- A. Starter Solenoid to Starter Motor Cable Chaffing - 1974 Merc 650
- B. Exhaust Cover Screw Torque - 1973-74 Merc 650
- C. Relief Valve Diaphragm Bleed Hole Leakage - 1974 Merc 650

## A. STARTER SOLENOID to STARTER MOTOR CABLE CHAFFING - 1974 Merc 650

Figure 1. BEFORE Relocating Cable

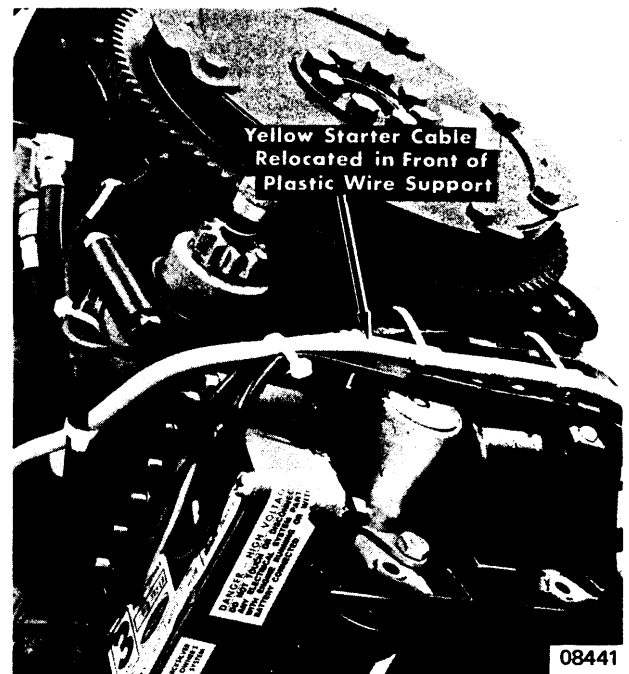
A starter motor change on 1974 Merc 650 Outboards (below Serial No. 3813358) could cause the yellow starter cable to chafe on the switch box. (Figure 1) To remedy, relocate the yellow cable and sta-straps (C-61990) as shown in Figure 2. Complete this relocation on all 1974 Merc 650's below Serial No. 3813358 at a labor allowance of 0.3 hr.
